Bullock Creek School District
2024 Bond- Series 2 - 2027 Renovations
HS / MS / Floyd and Pine River Elementary Schools

ADDENDUM #1

Project: No. 26-210 Bullock Creek 2023 Bond Series 2
2027 Improvements

Issue Date: November 2, 2026

SEAL		
	DRAWN KRS	PROJECT NO. 26-210
	CHECKED JESS	CAD FILE NO. A-A101
	REVIEWED MLB	DRAWING NO. A-A101
	DATE OCT 19, 2026	SHEET NO. 3 OF 20
	SCALE AS NOTED

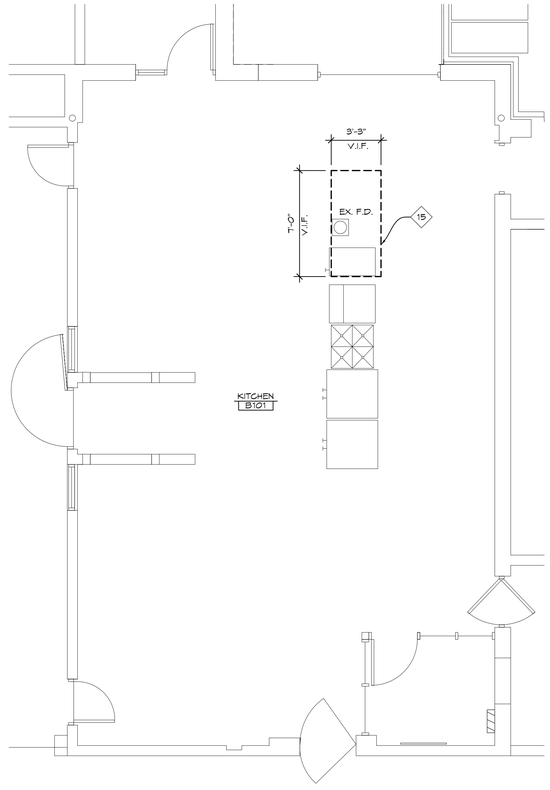
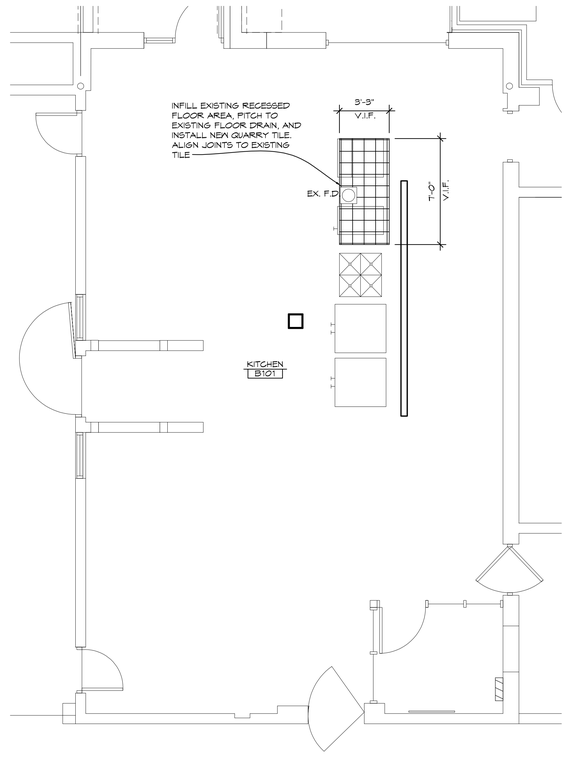
Item #A2: Revise Sheet A-A101 as follows:

a. Several existing Water Closets in Wings 'A', 'B', 'D', and 'E' are to remain.
b. Existing Door leaf at Room A139 to be removed and replaced with a new Door panel A102.
c. One existing Drinking Fountain has been eliminated and corresponding Note changed on Enlarged Plan 5/A-A101.
d. Demolition Notes 2, 5, and 14 have been changed.
e. Note 5 has been changed to Note 14 on Enlarged Plan 4/A-A101.
f. Note 14 has been changed to Note 5 on Enlarged Plan 1/A-A101.
g. Demolition Note 16 has been added.

SEAL	DRAWN CJV/KLS	PROJECT NO. 26-210
	CHECKED KLS	CAD FILE NO. A-P101
	REVIEWED MLB	DRAWING NO. A-P101
	DATE OCT 19, 2026	
	SCALE AS NOTED	SHEET NO. 11 OF 20

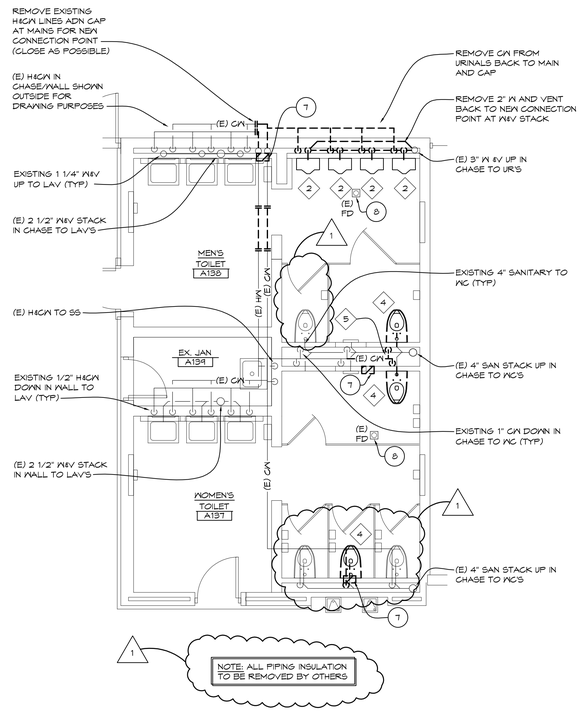
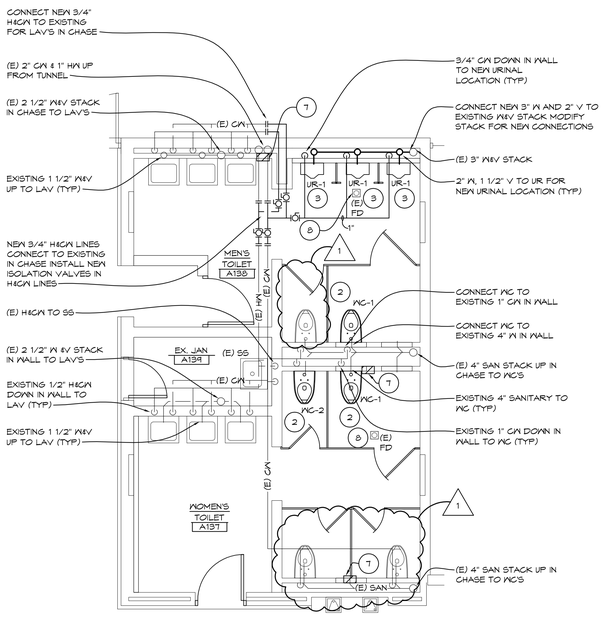
Item #P1: Revise Sheet A-P101 as follows:

a. General Note "ALL PIPING INSULATION TO BE REMOVED BY OTHERS" added to Plans.
b. (FOR CLARIFICATION) Note to remove and reinstall two Water Closets in Women's Toilet A137 and one Water Closet in Men's Toilet A138 have been removed on Demolition and Plumbing Plans. Water Closets to remain in place.

'B' WING TOILET ROOMS ABOVE FLOOR
PLUMBING DEMOLITION PLAN

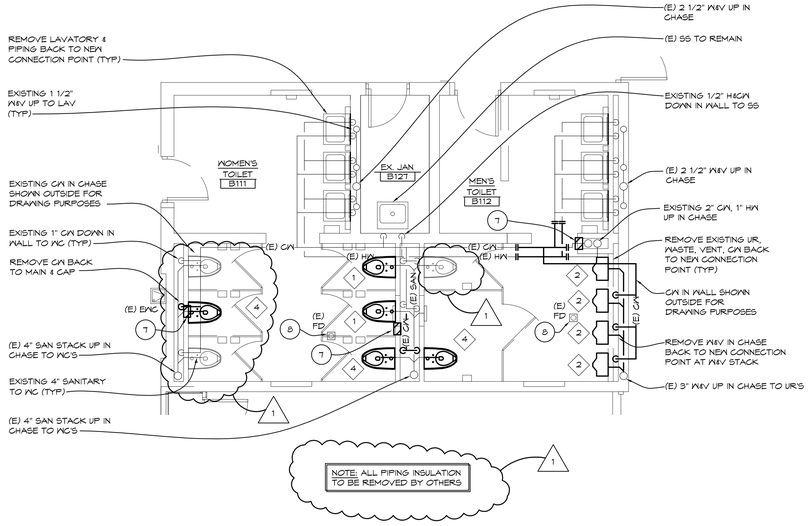
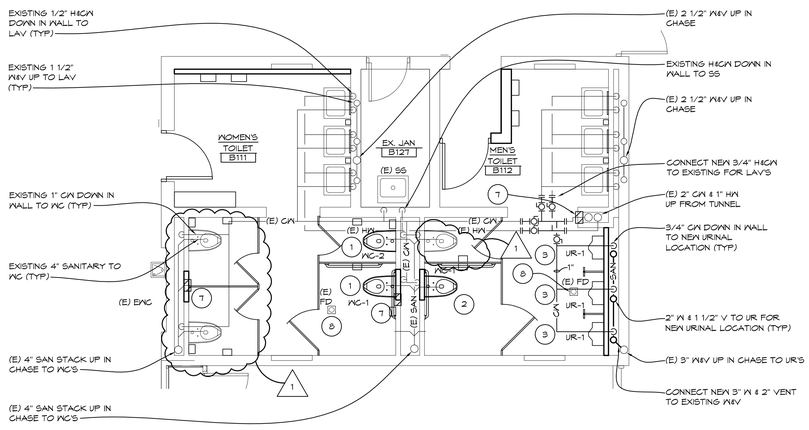
Item #P2: Revise Sheet A-P102 as follows:

a. General Note "ALL PIPING INSULATION TO BE REMOVED BY OTHERS" added to Demolition Plans.
b. (FOR CLARIFICATION) Note to remove and reinstall two Water Closets in Women's Toilet B111 and one Water Closet in Men's Toilet B112 have been removed on Demolition and Plumbing Plans. Water Closets to remain in place.

SEAL	DRAWN CJV/KLS	PROJECT NO. 26-210
	CHECKED KLS	CAD FILE NO. A-P103
	REVIEWED MLB	DRAWING NO. A-P103
	DATE OCT 19, 2026	SHEET NO. 13 OF 20
	SCALE AS NOTED

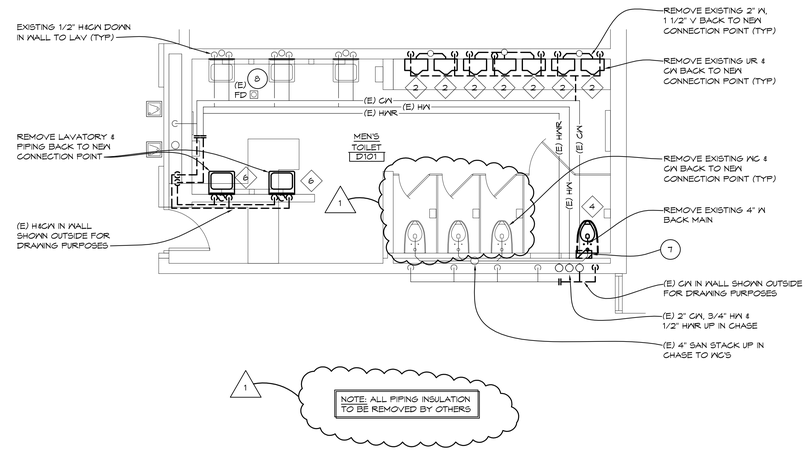
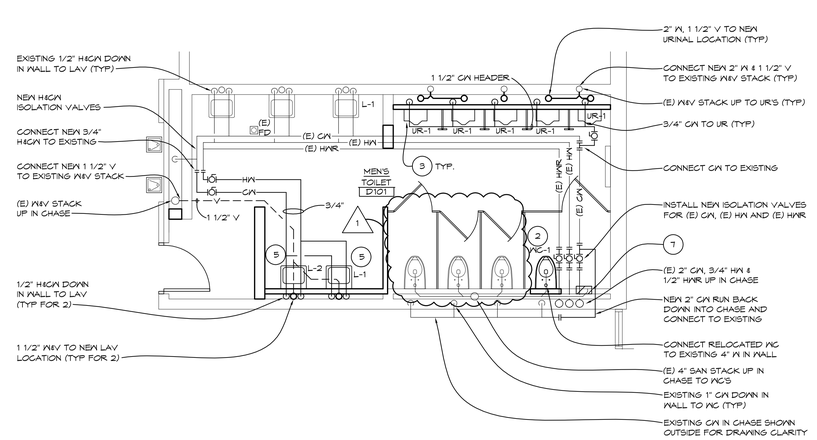
Item #P3: Revise Sheet A-P103 as follows:

a. General Note "ALL PIPING INSULATION TO BE REMOVED BY OTHERS" added to Demolition Plans.
b. (FOR CLARIFICATION) Note to remove and reinstall three Water Closets in Men's Toilet D101 have been removed on Demolition and Plumbing Plans. Water Closets to remain in place.

SEAL	DRAWN CJV/KLS	PROJECT NO. 26-210
	CHECKED KLS	CAD FILE NO. A-P104
	REVIEWED MLB	DRAWING NO. A-P104
	DATE OCT 19, 2026	SHEET NO. 14 OF 20
	SCALE AS NOTED

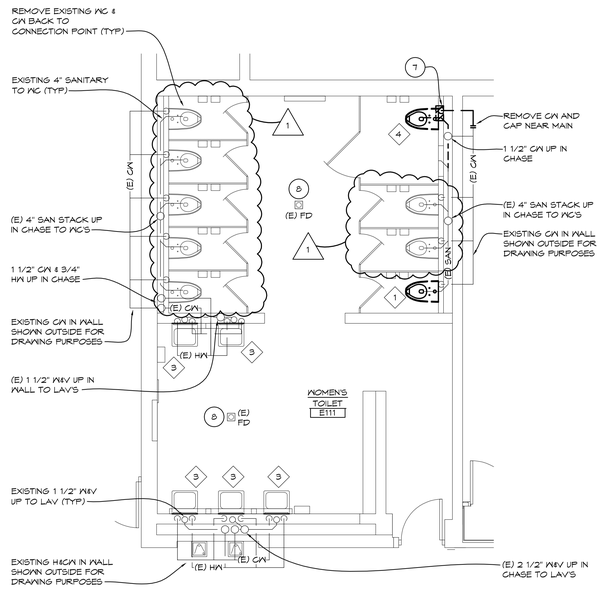
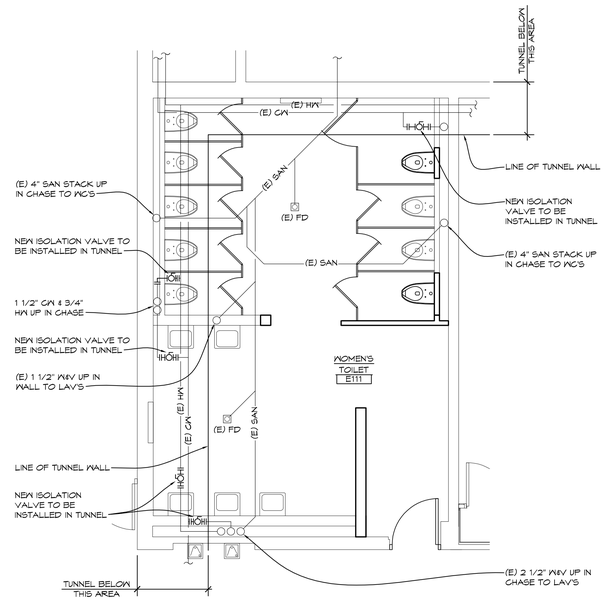
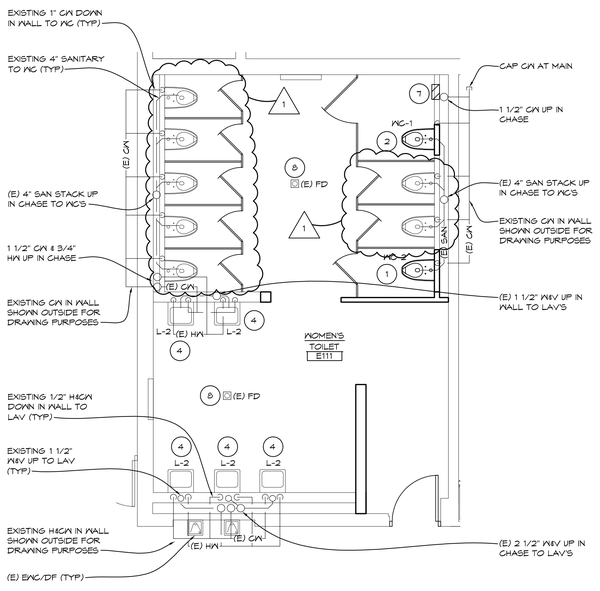
Item #P4: Revise Sheet A-P104 as follows:

a. General Note "ALL PIPING INSULATION TO BE REMOVED BY OTHERS" added to Demolition Plans.
b. (FOR CLARIFICATION) Note to remove and reinstall seven Water Closets in Women's Toilet E111 have been removed on Demolition and Plumbing Plans. Water Closets to remain in place.

SEAL	DRAWN TJA	PROJECT NO. 26-210
	CHECKED RCH	CAD FILE NO. A-E102
	REVIEWED RCH	DRAWING NO. A-E102
	DATE OCT 19, 2026	SHEET NO. 18 OF 20
	SCALE AS NOTED

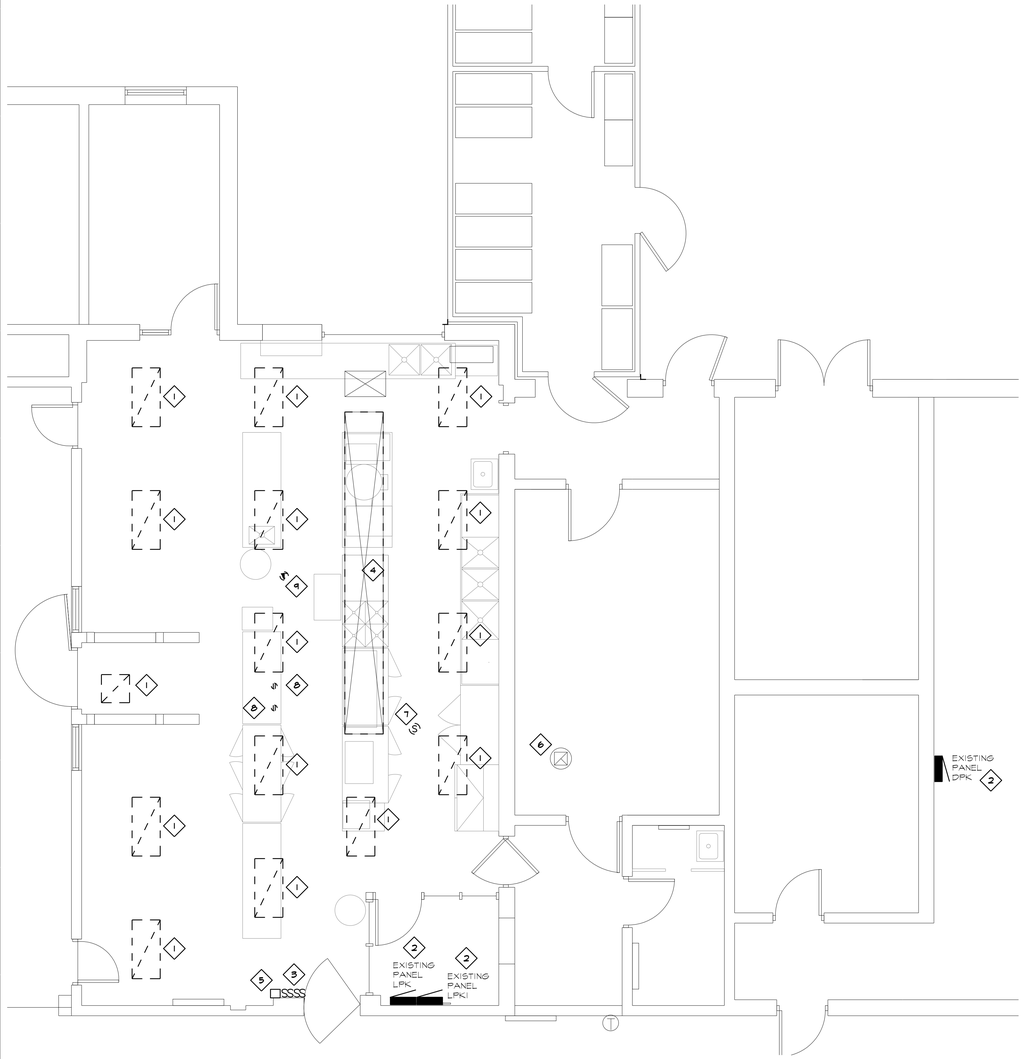
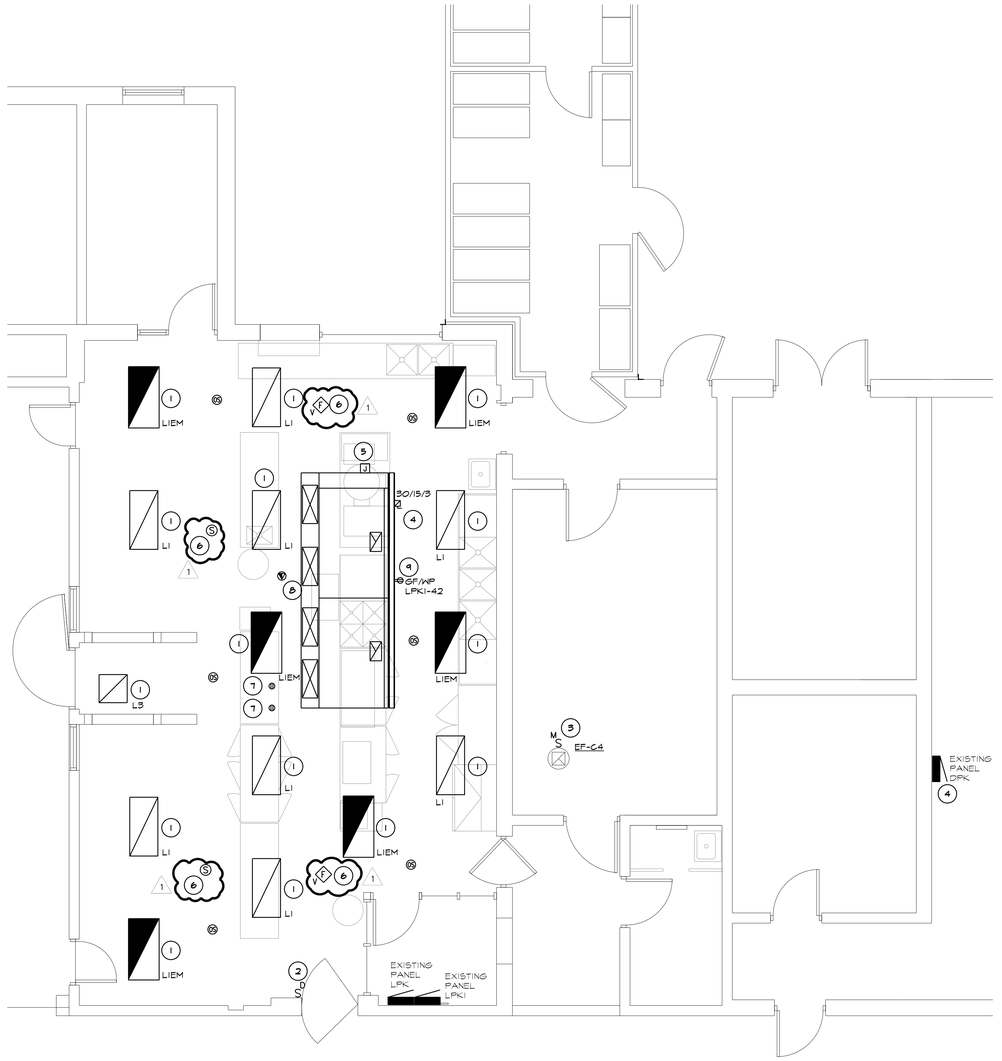
Item #E2: Revise Sheet A-E102 as follows:

SEAL	DRAWN KRS	PROJECT NO. 26-210
	CHECKED JESS	CAD FILE NO. B-G001
	REVIEWED MLB	DRAWING NO. B-G001
	DATE OCT 14, 2026	SHEET NO. 1 OF 38
	SCALE N.T.S.

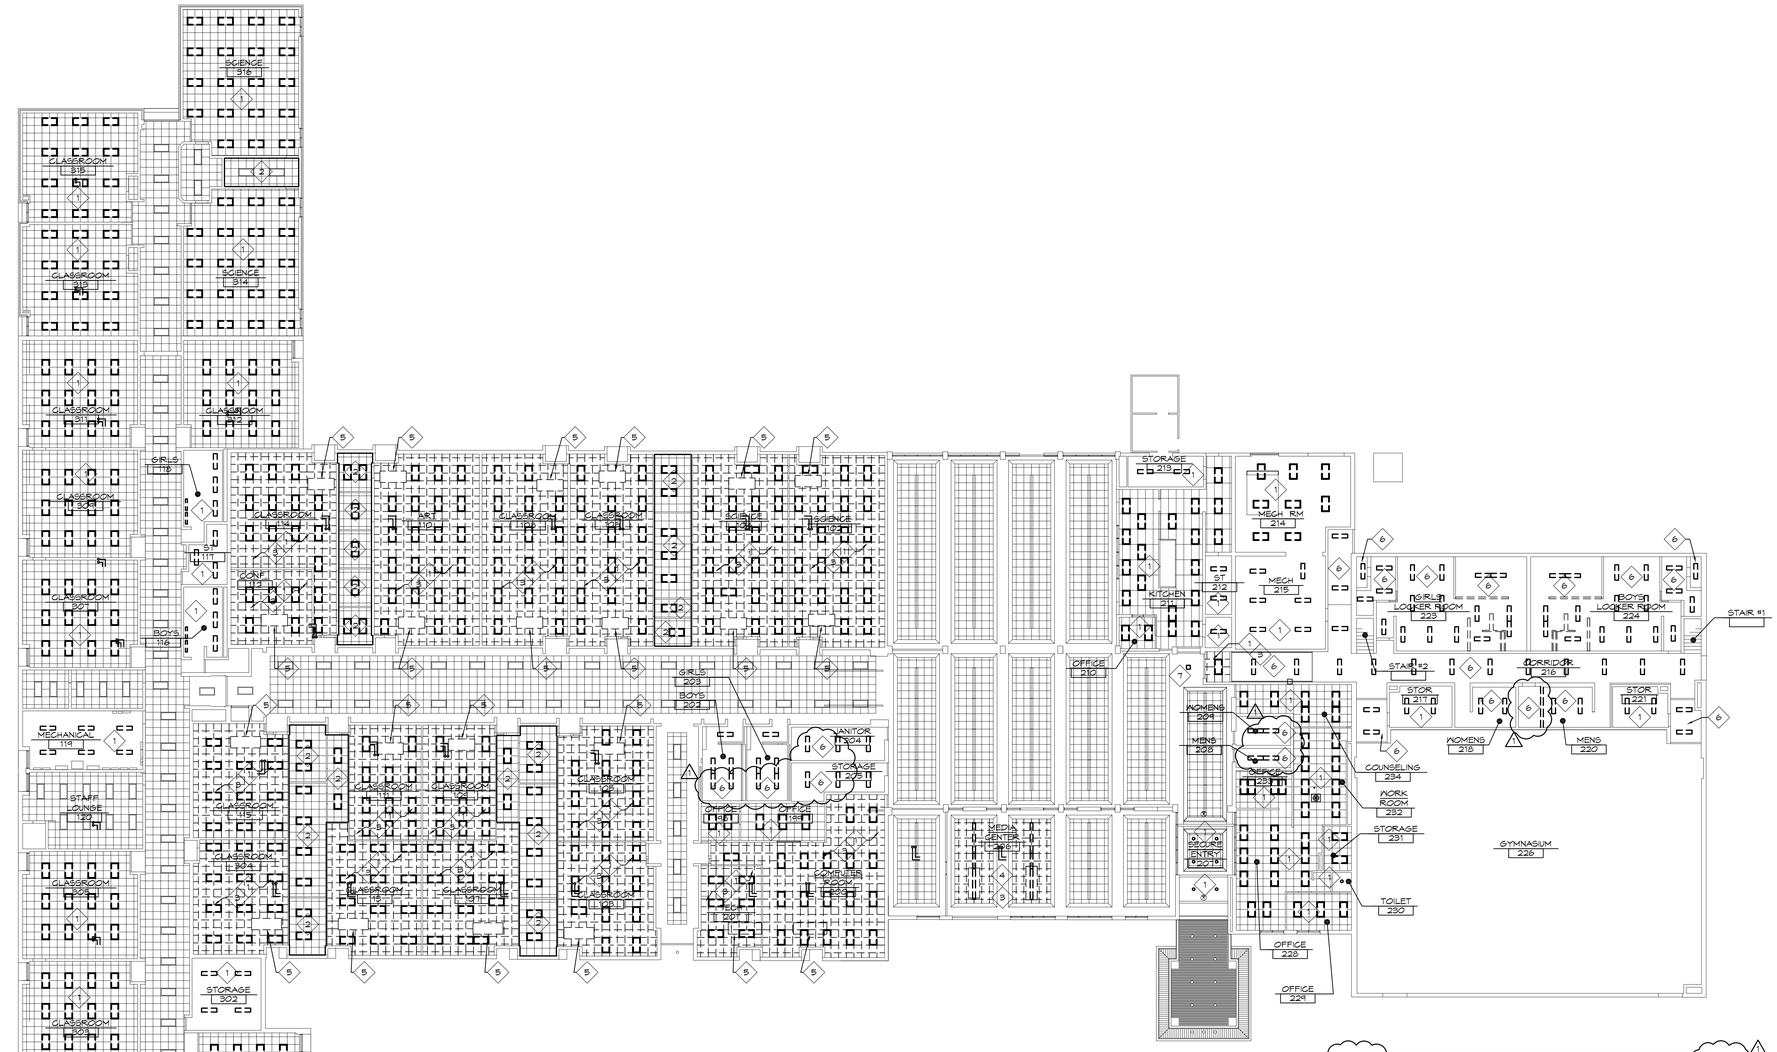
Item #A5: Revise Sheet B-G001 as follows:

a. Fire Separation Legend and Fire Separation Notes have been added.
b. Existing fire barriers have been added to Composite Plan.
c. Applicable Codes and Ordinances have been changed.

SEAL	DRAWN KRS	PROJECT NO. 26-210
	CHECKED JESS	CAD FILE NO. B-A102
	REVIEWED MLB	DRAWING NO. B-A102
	DATE OCT 19, 2026	SHEET NO. 3 OF 38
	SCALE AS NOTED

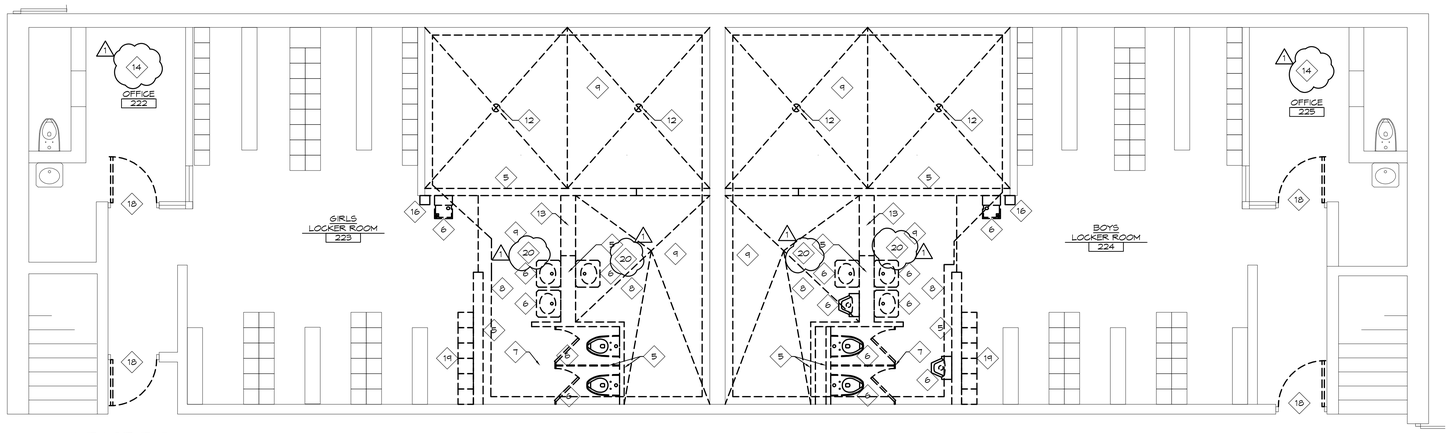
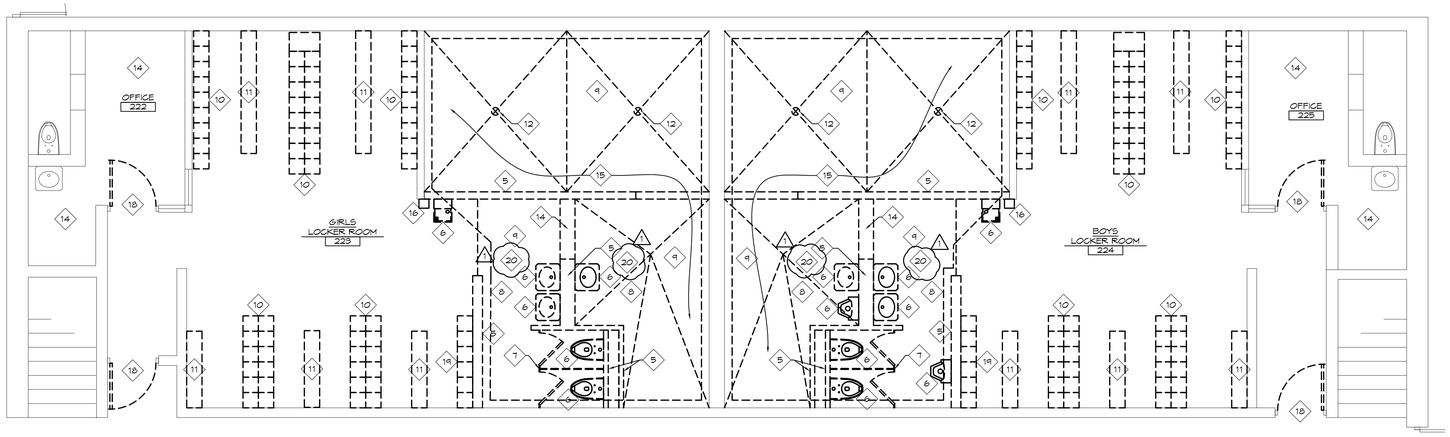
Item #A6: Revise Sheet B-A102 as follows:

a. Note 6 has been added to Demolition Ceiling Plan. At seven locations.
b. Note 6 has been added to Mezzanine Demolition Reflected Ceiling Plan. At two locations.
c. Note 7 has been eliminated from Mezzanine Reflected Ceiling Plan.
